NOTICE TO CONTRACTORS BIDDING THIS PROJECT

Project Title: Building and Site Improvements at 6741 Downing Avenue, Bakersfield, CA

Contract No: 26016

ADDENDUM No. 5

JCB	C2A SHEET 2 OF 9
DP	
PM

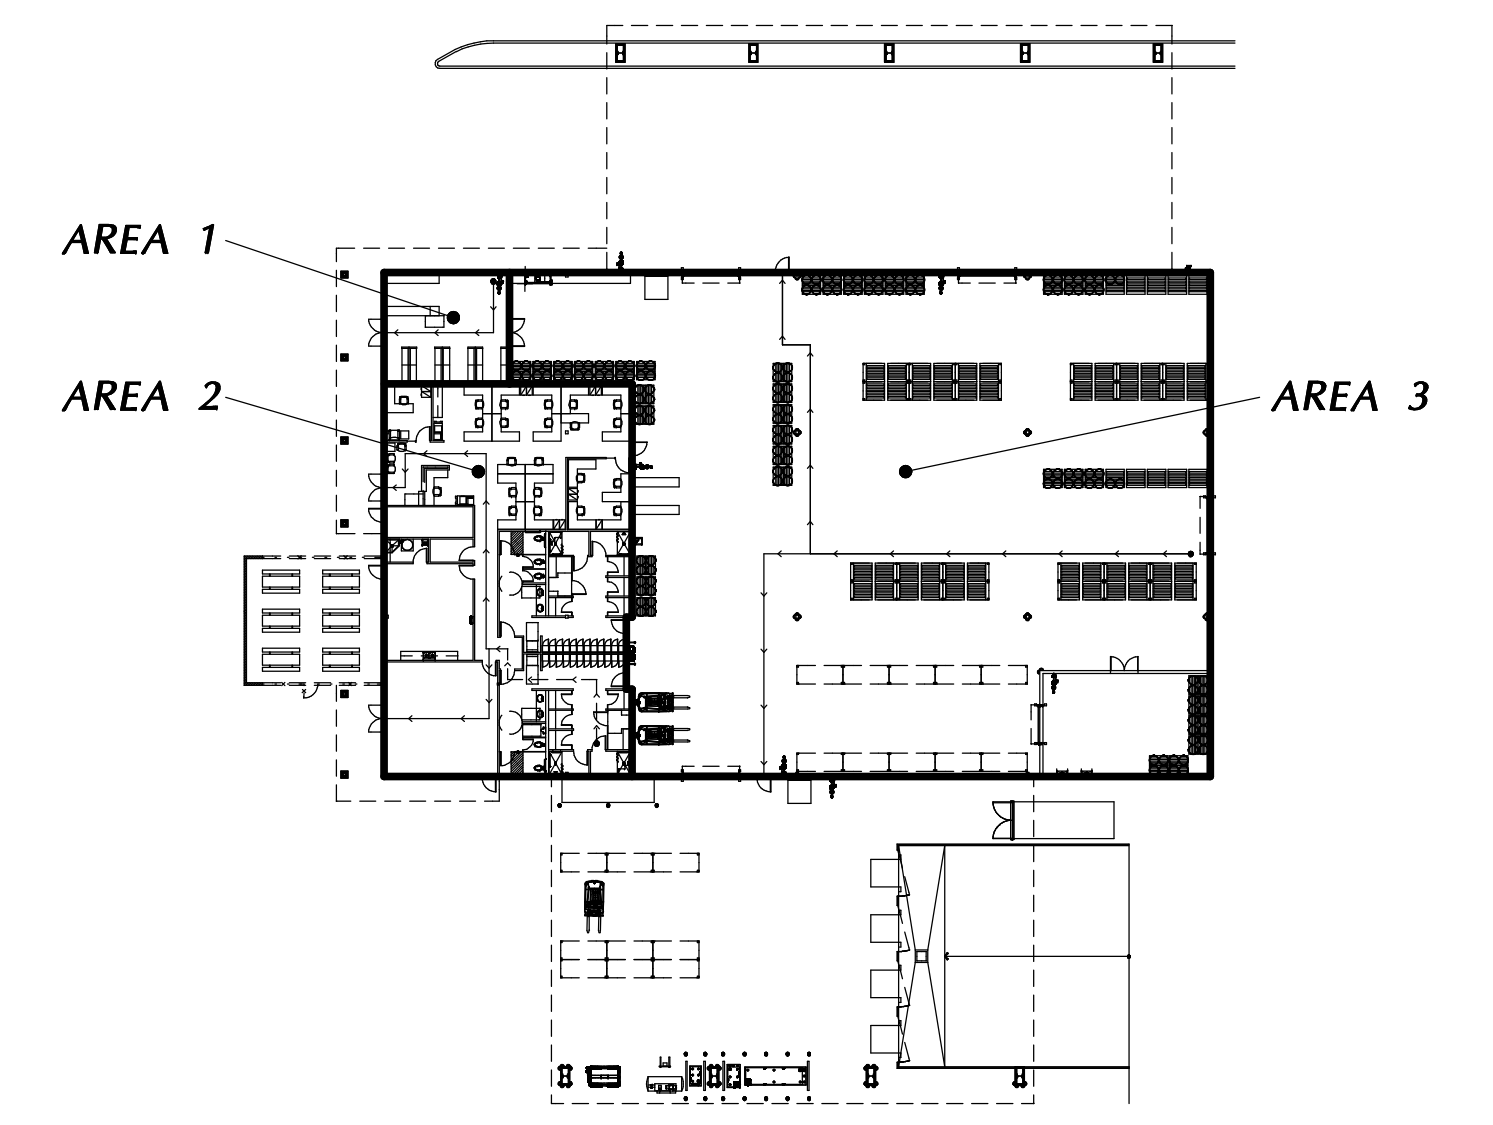
- c. Sheet C2 has been replaced with sheet C2A. Detail references have been corrected. Pole-mounted site lighting locations have been updated. Storm drain information has been revised. The revised sheet is attached to this addendum.

JOB	7005
DP	ACJ/N
PM	GUF
	A100B

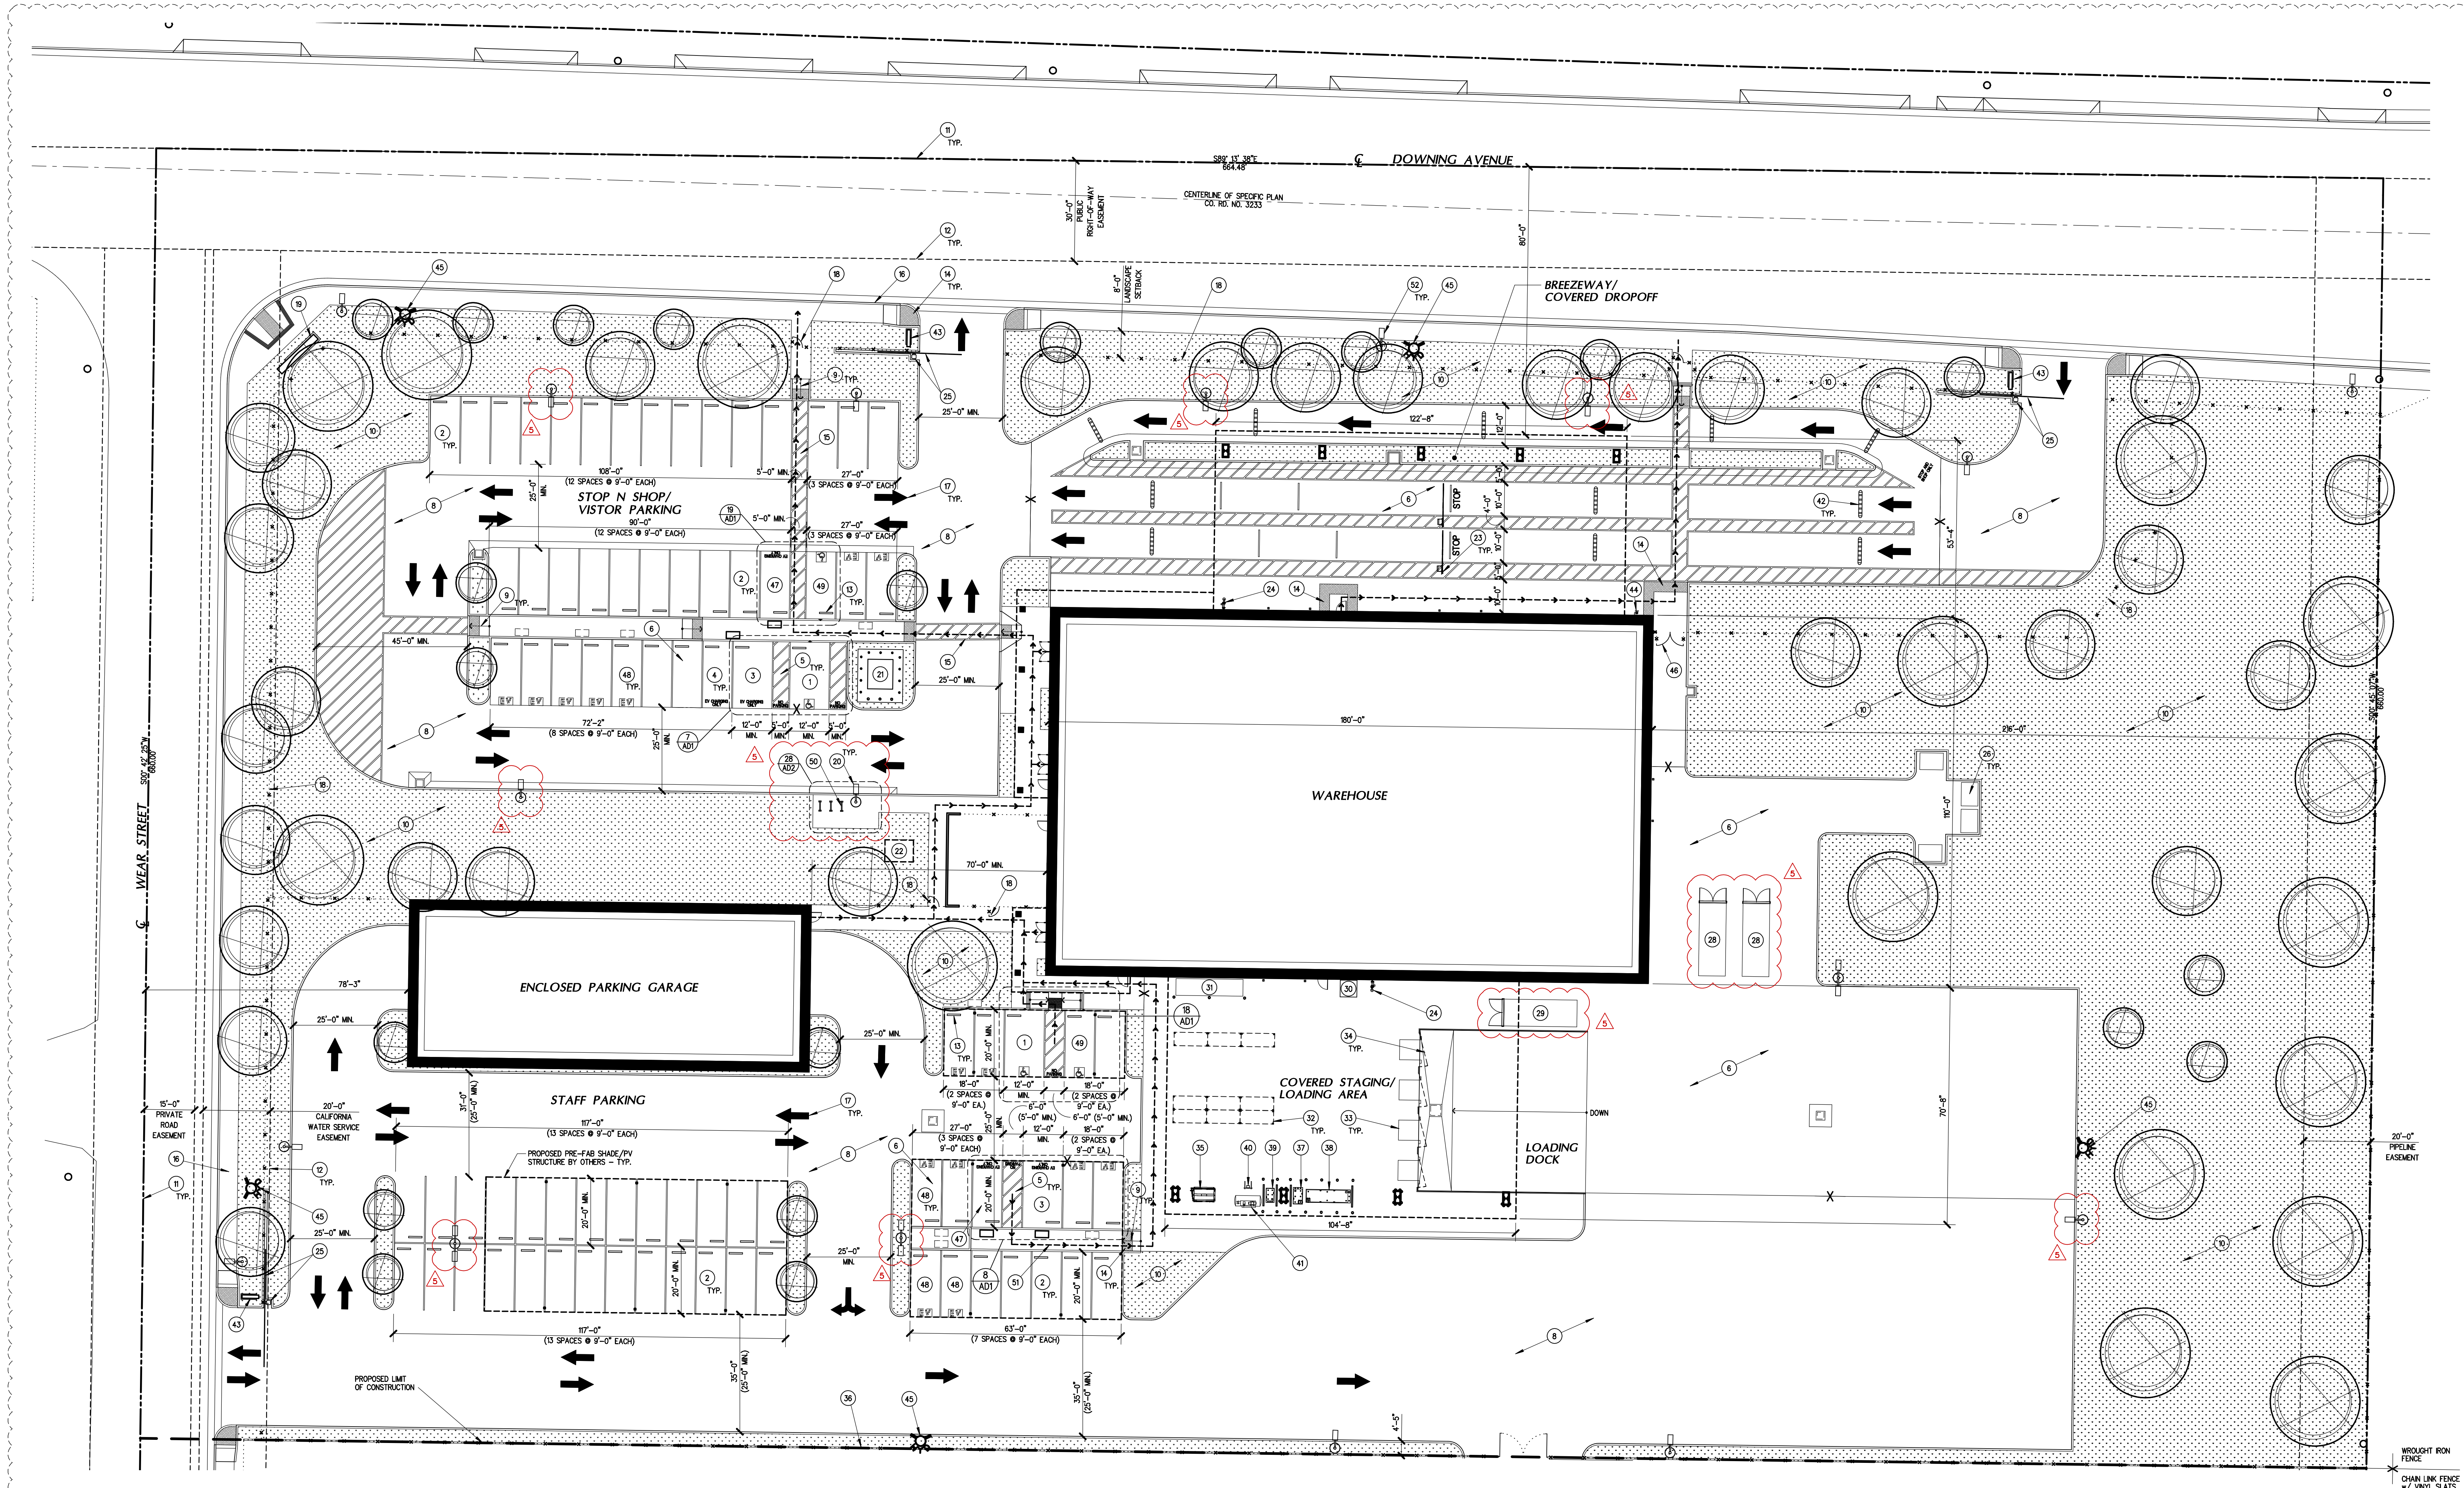
- g. Sheet A100A has been replaced with sheet A100B. The C-channel skids have been removed from the scope of work. Bins shall be placed directly on the concrete. Additional information for the in-ground scale has been added. Additional information for items listed to be "by others" and "by owner" has been provided. EV charger specifications have been added. Pole-mounted site lighting locations have been updated. Bike rack information has been added. Hardware for exterior gate has been provided on keynote #18. Detail callouts on keynotes #19 and #43 have been corrected. The revised sheet is attached to this addendum.

JOB 7005	A211B
DP AC/JV	
PM GUF

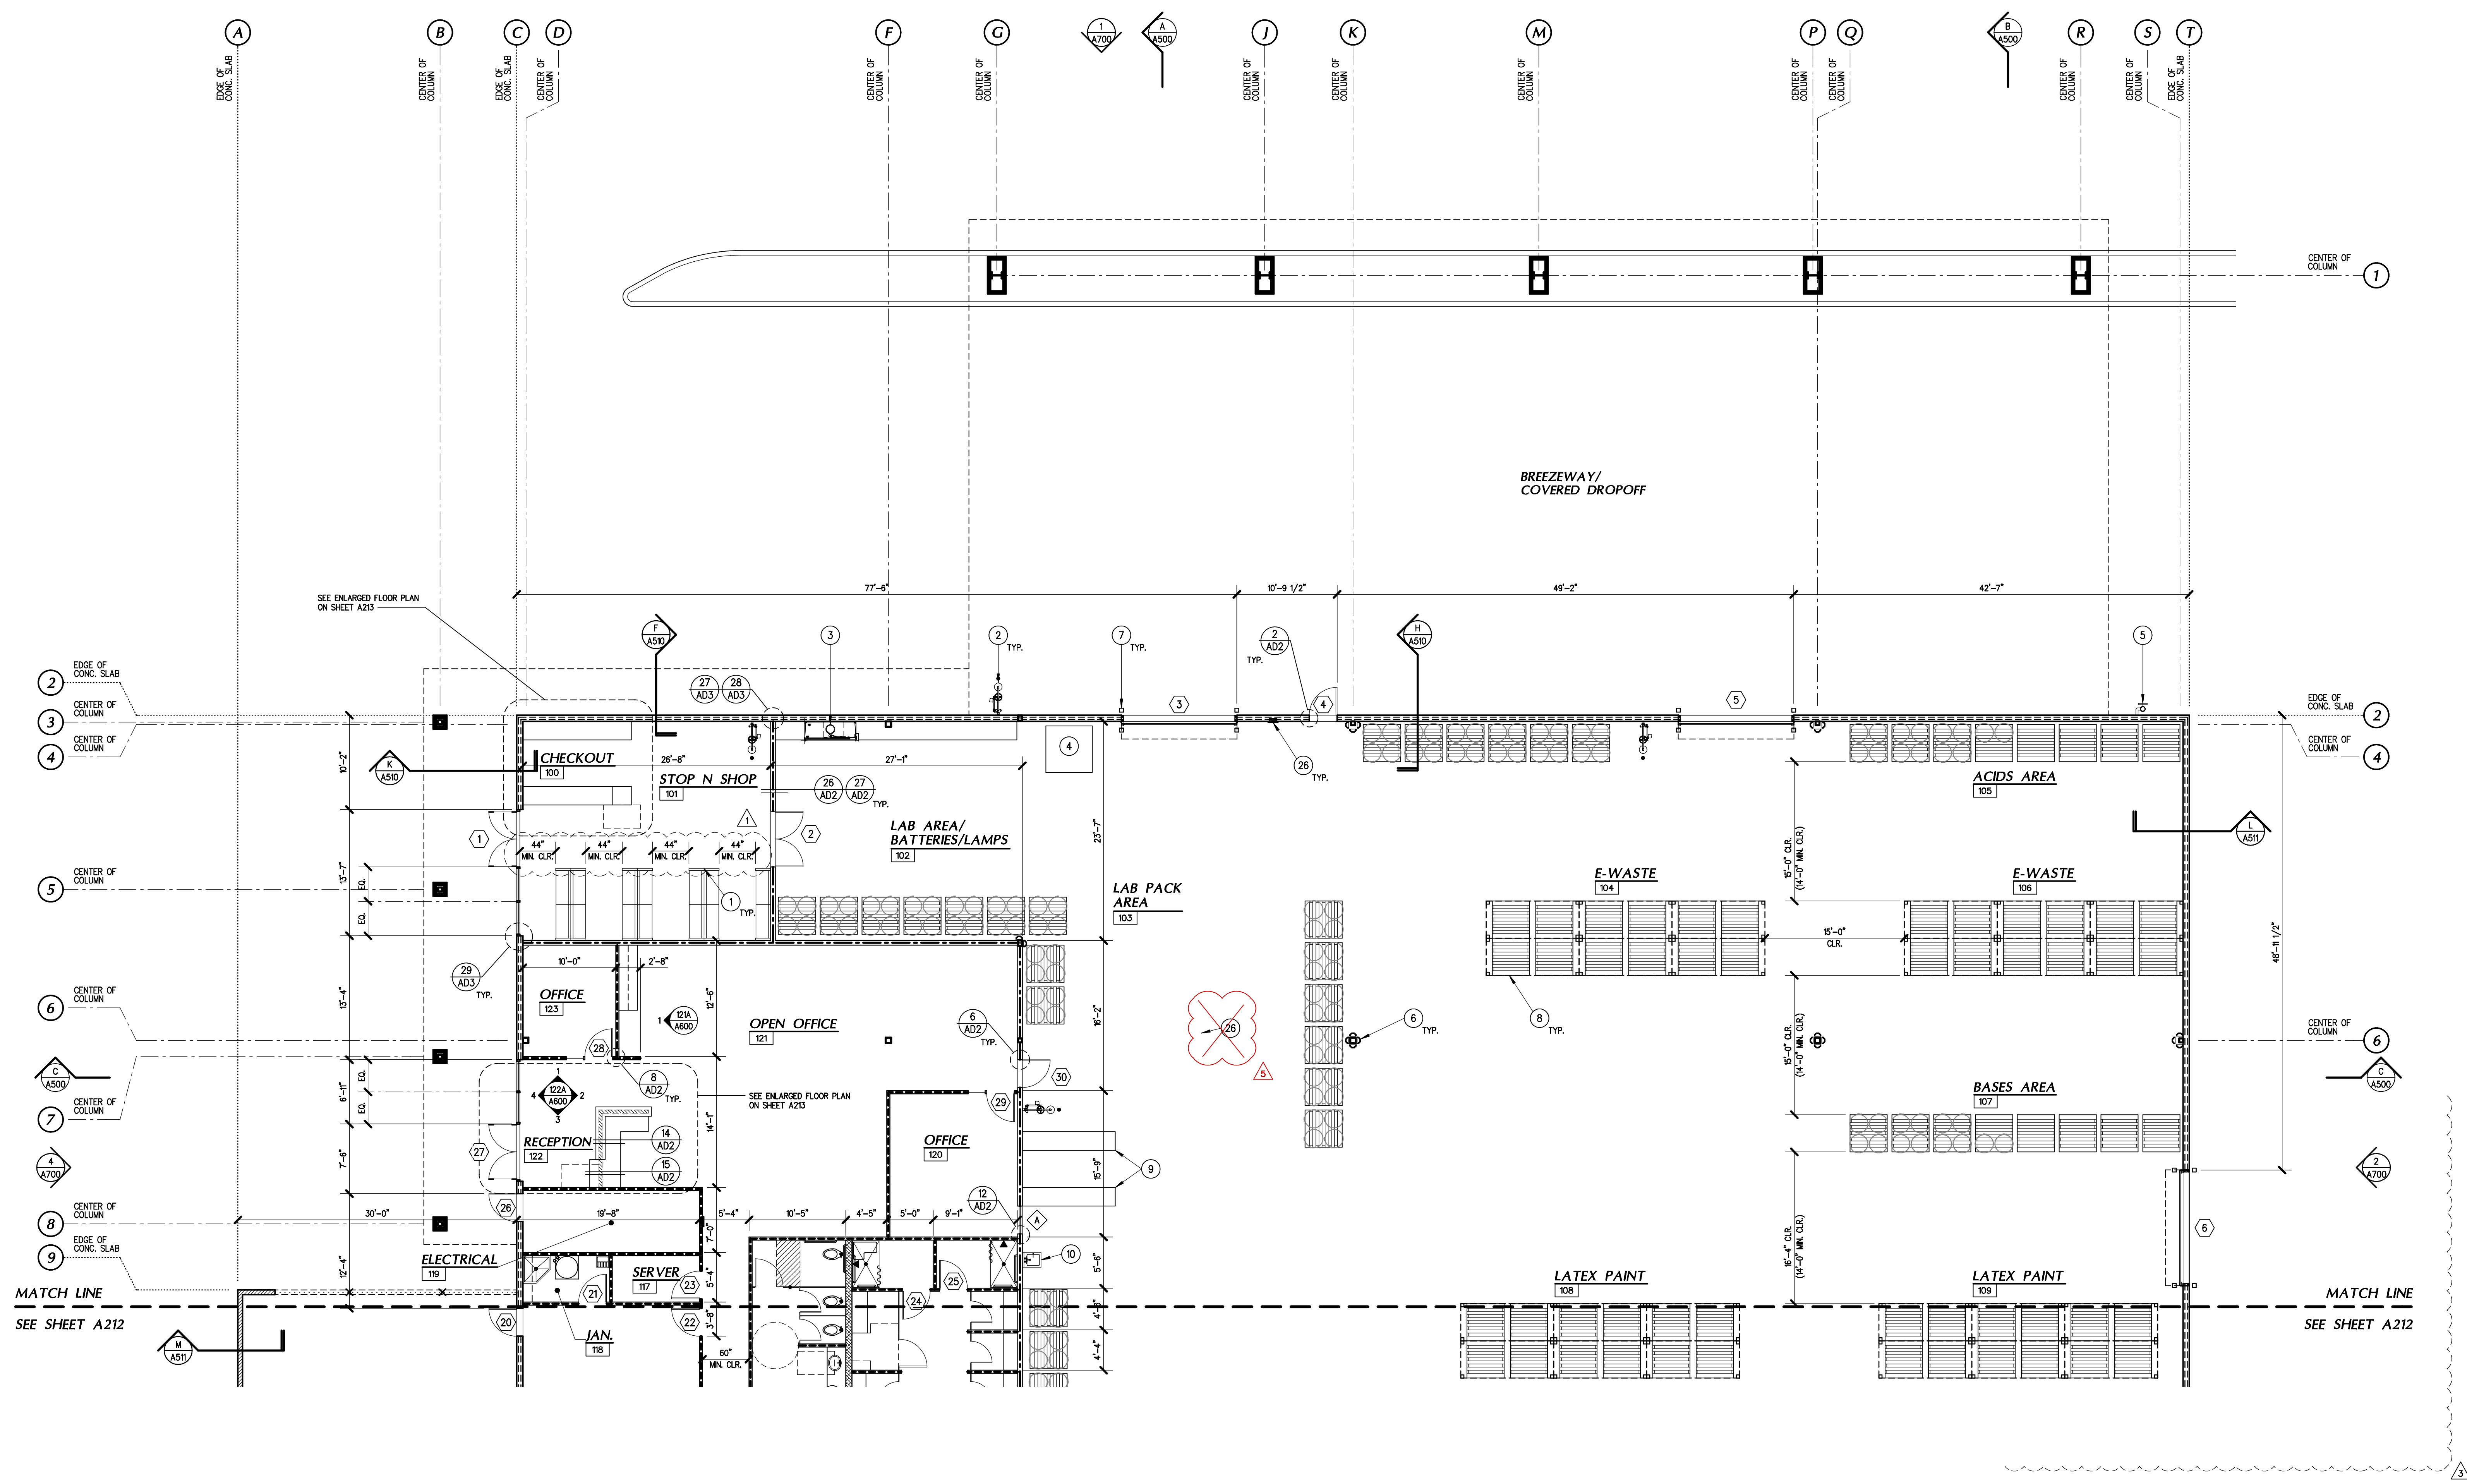
- h. Sheets A211A and A212A have been replaced with sheets A211B and A212B. Keynote #26 has been clarified. Items shown as "by owner" and "by others" have been clarified to be provided and installed by the contractor. Storefront finish has been updated. Fire extinguisher specification and locations have been added. Storage shelving information has been added. Bollard information has been added. The revised sheet is attached to this addendum.
